Re: Goose Haven Reservoir M-2010-071 Response to Adequacy #4

**Re: DRMS Permit No. M-2010-071 AM-2 Adequacy Review Response No. 4**

FIGURE 1

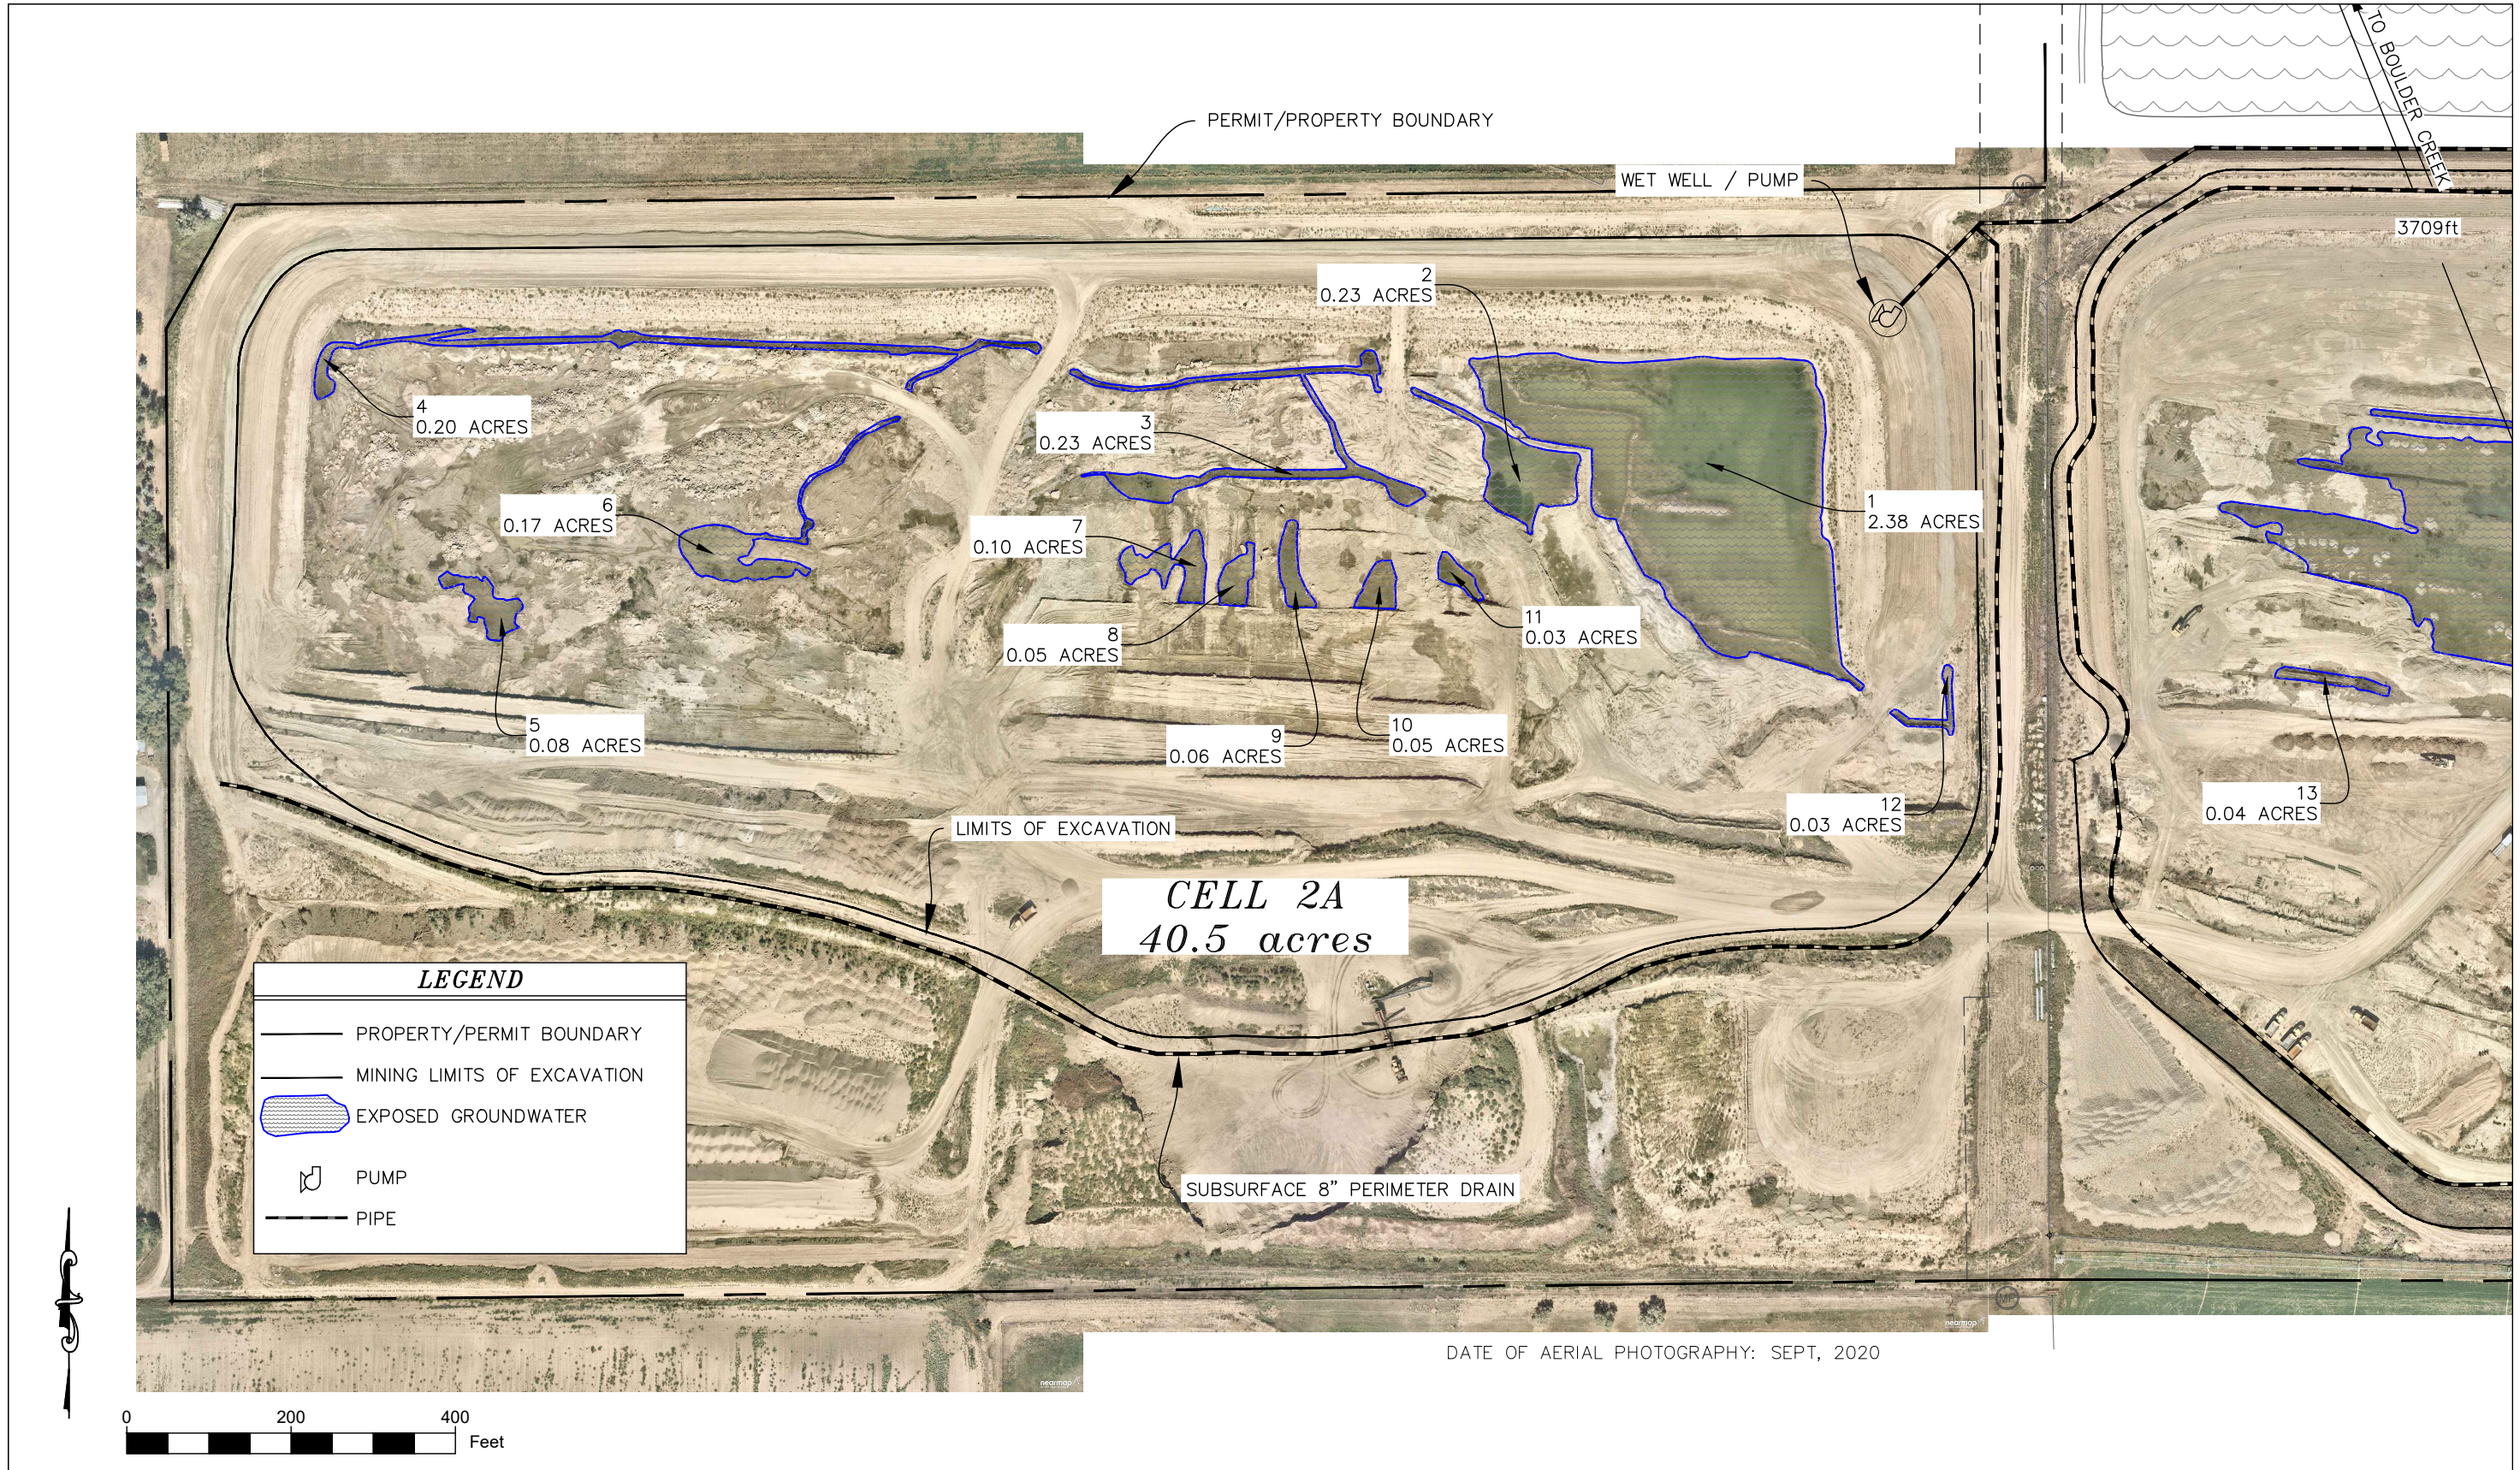
**1.** The Division could not locate the requested map that depicts the current monitoring well locations and the locations of the proposed monitoring wells. Please provide the missing map and the Division will evaluate the proposed locations for adequacy.

***Figure 1 from the McLaughlin Water Engineers Groundwater Monitoring & Mitigation Plan showing existing piezometers has been enclosed. Additionally, the same wells are shown in GW-1, GW-2. GW-3 has been replotted to adobe to now show both existing and proposed piezometers.***
